<b>HYUNDAI</b> <b>Technical Service Bulletin</b>	<b>GROUP</b> <b>RECALL</b>	<b>NUMBER</b> <b>18-01-005</b>
	<b>DATE</b> <b>JANUARY, 2018</b>	<b>MODEL(S)</b> <b>Elantra (MD/UD)</b> <b>Elantra Coupe (JK)</b> <b>Elantra GT (GD)</b>
<b>SUBJECT:</b> 2013-2014 ELANTRA (MD/UD, JK, GD) BRAKE PEDAL STOPPER REPLACEMENT (RECALL CAMPAIGN 170)

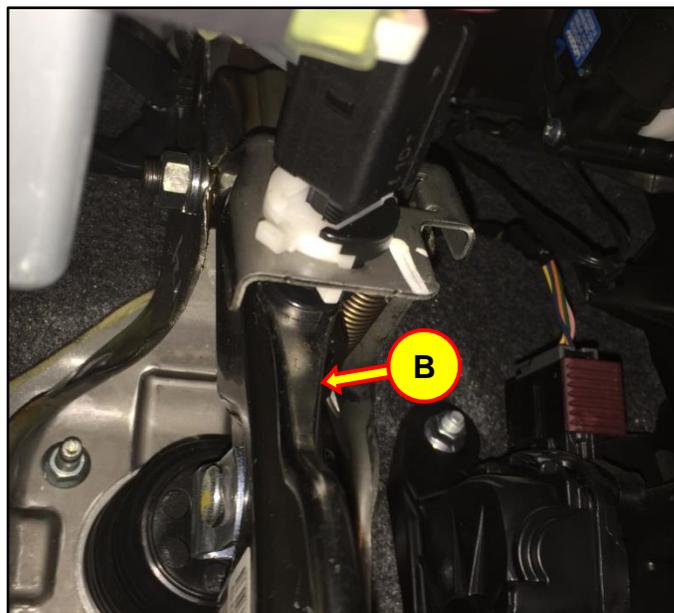
4. The stopper (A) is mounted on the brake pedal, in-line with the stop lamp switch.

5. Insert the clip/trim tool (B) between the stopper and brake pedal as shown. Then carefully pry off the stopper.

6. Destroy the removed stopper by cutting the nub off. Discard the pieces.

7. Install a new stopper by pressing it into place.

**Gap Specification:**

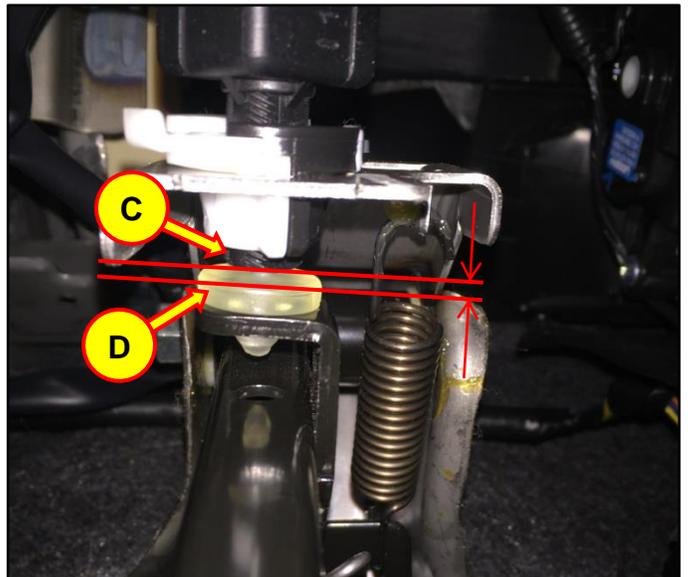
8. Without the brake pedal applied, adjust the gap between the end of the threaded housing of the stop lamp switch (C) and the stopper (D).

1.0 ~ 2.0 mm (0.04 ~ 0.08. in)
